CITY OF WESTFIELD, IN
Advisory Planning Commission Meeting Agenda_06_20_2016

1606-DDP-21

Urban Vines

Request: Detailed Development Plan approval for a vineyard and winery building on 5 acres +/-, and associated waivers.

Exterior
Elevations

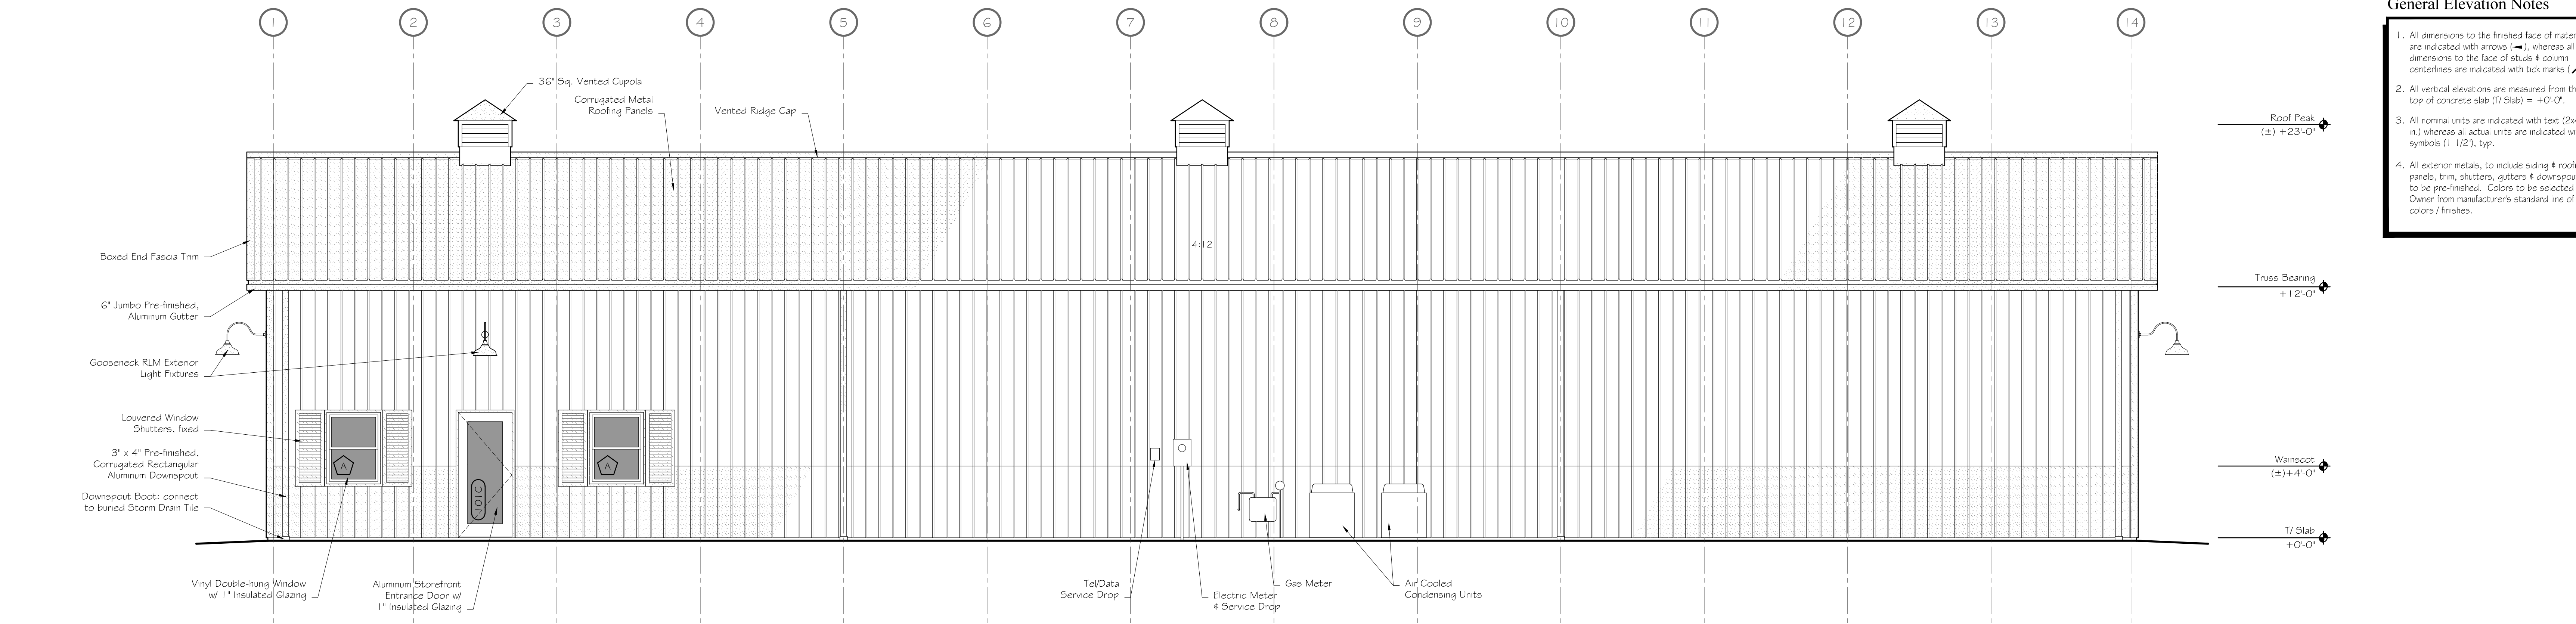
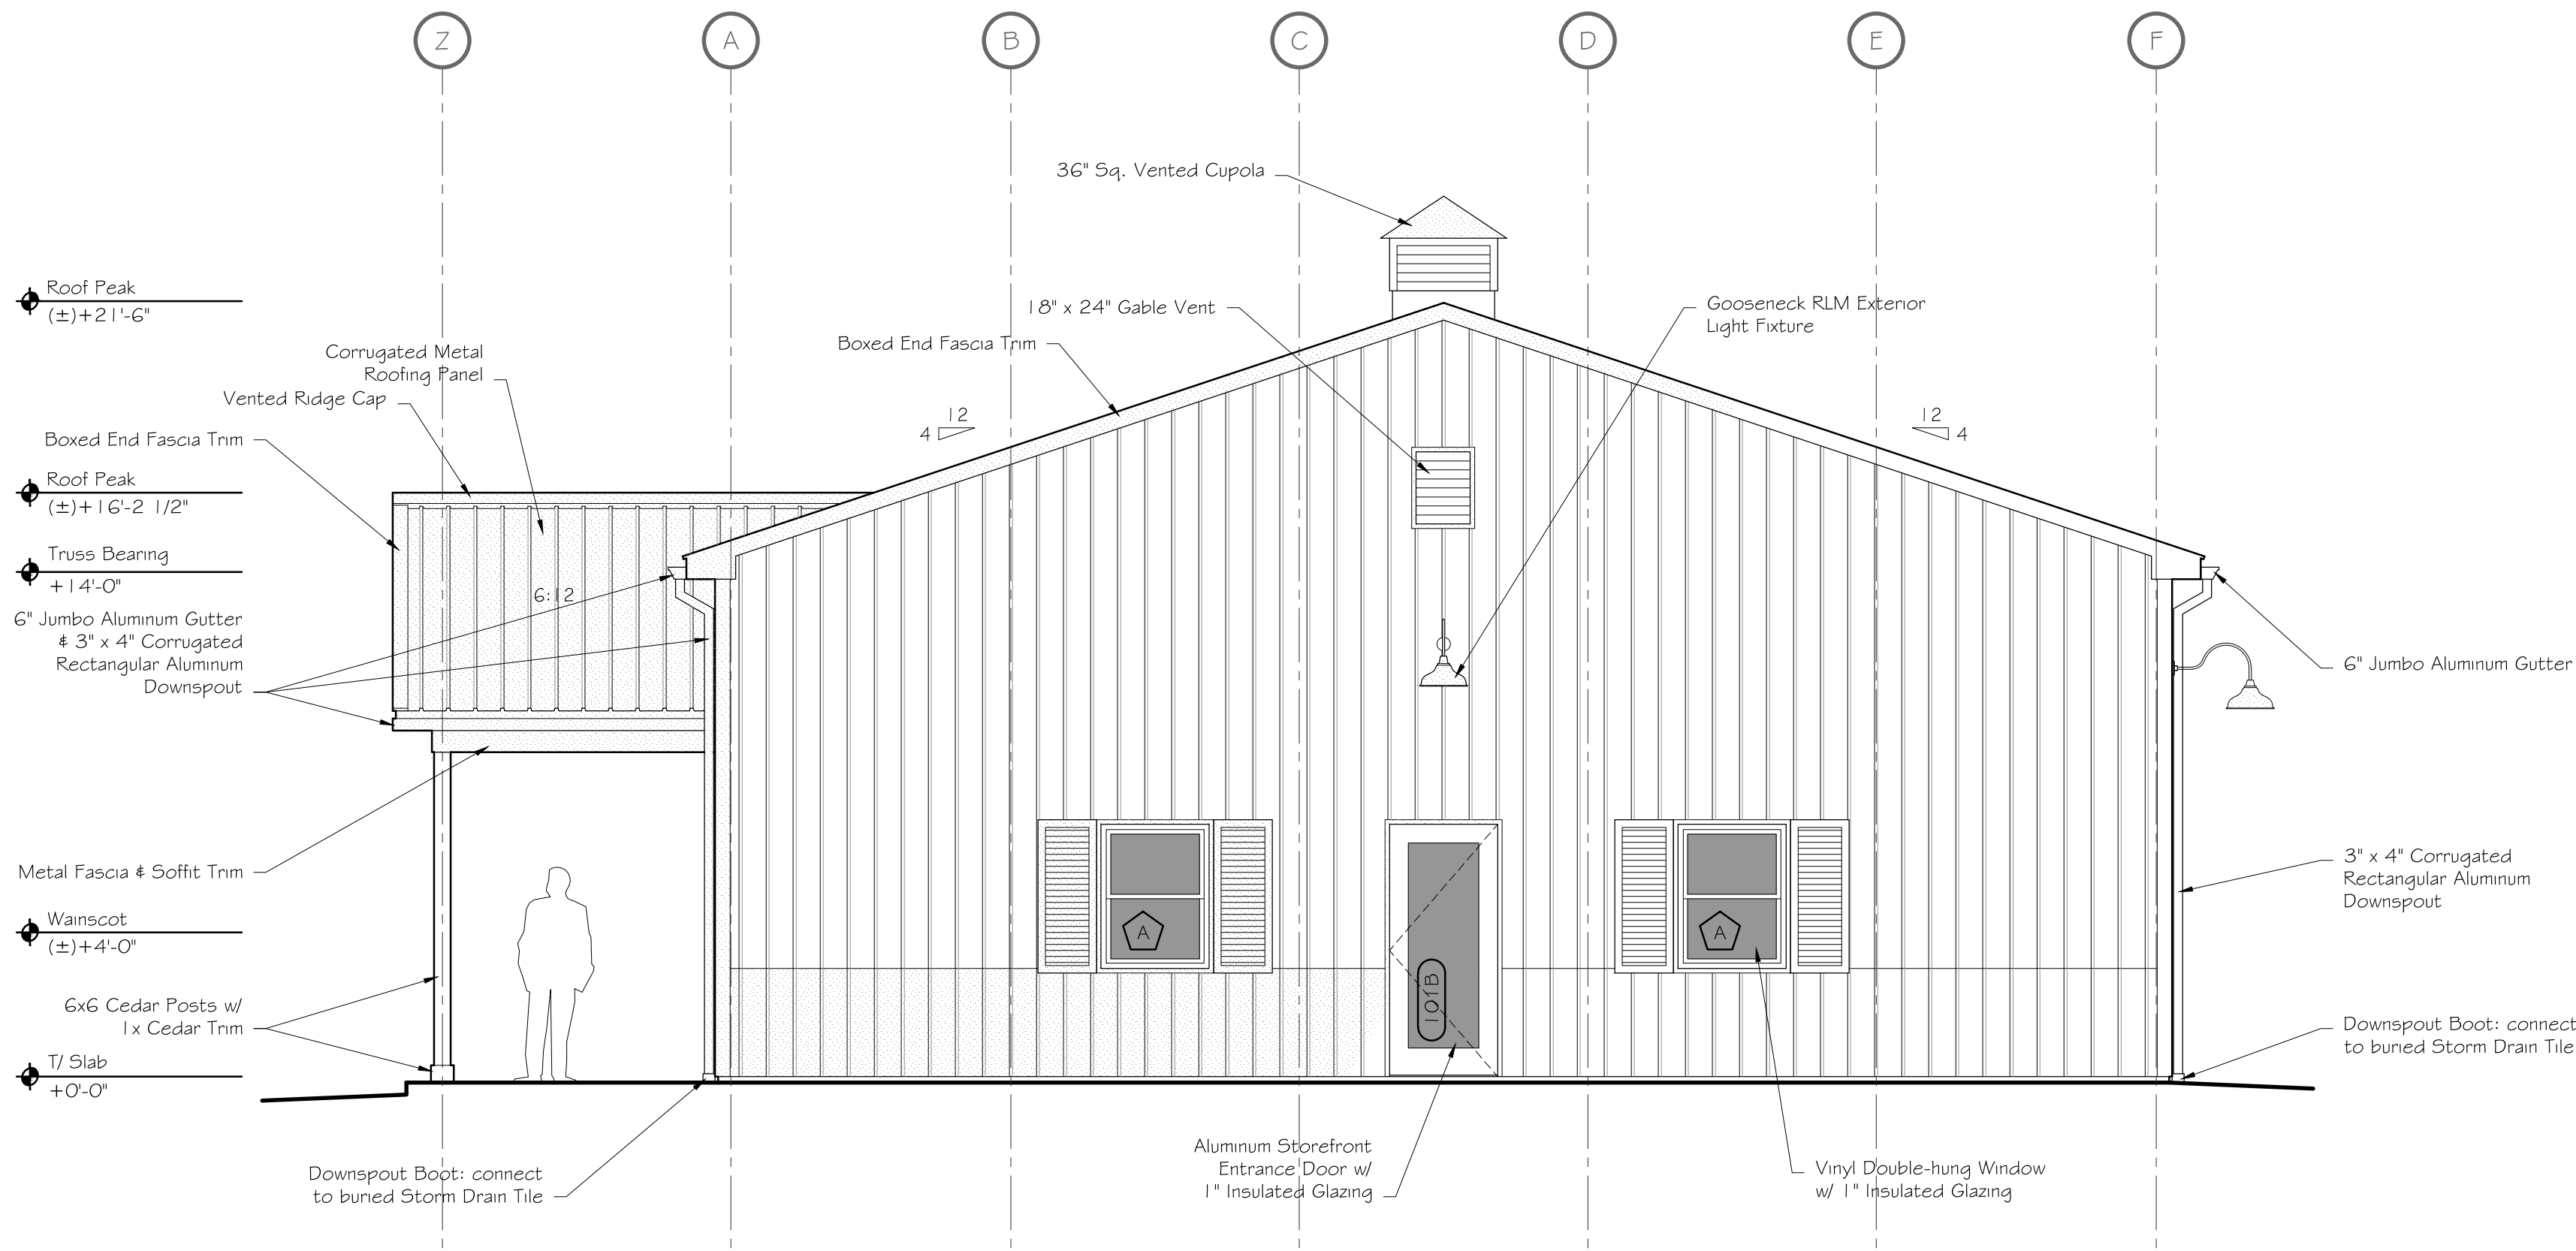
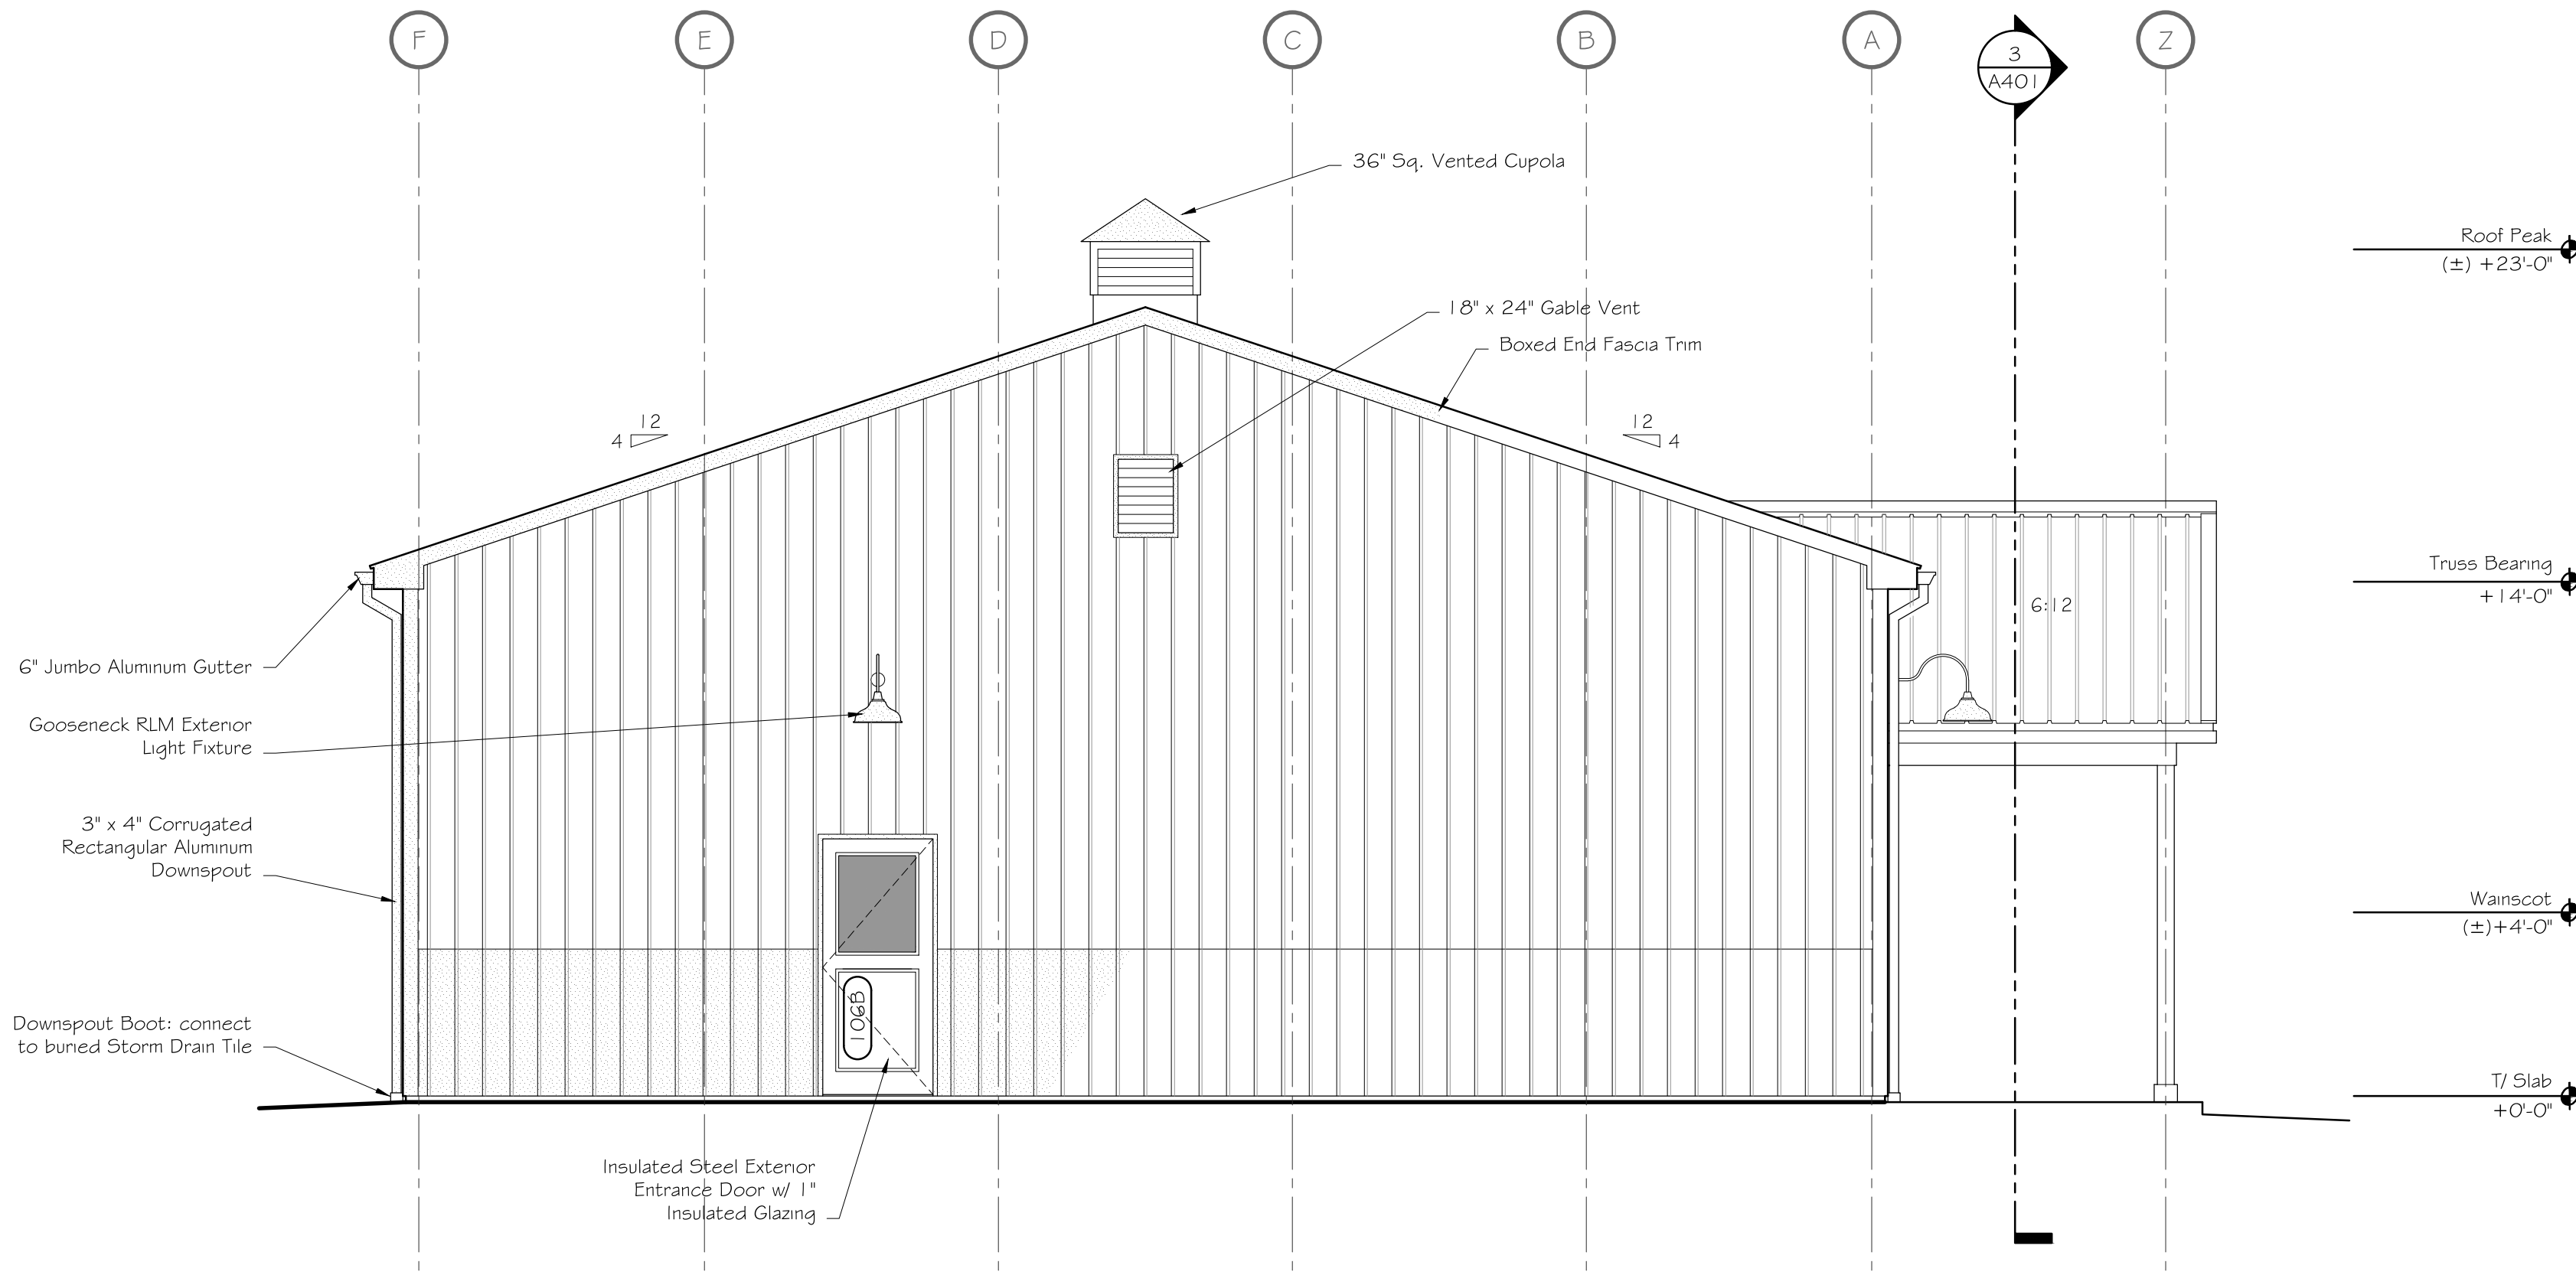
Comment: Does not apply pursuant to 1604-VS-07; however, the condition of approval requires buildings to exceed or be substantially similar in quality and character to the Illustrative Character Exhibit. Since the public hearing, the petitioner has revised the proposed building's design, as depicted in Exhibit 4, to address the comments from the public hearing.
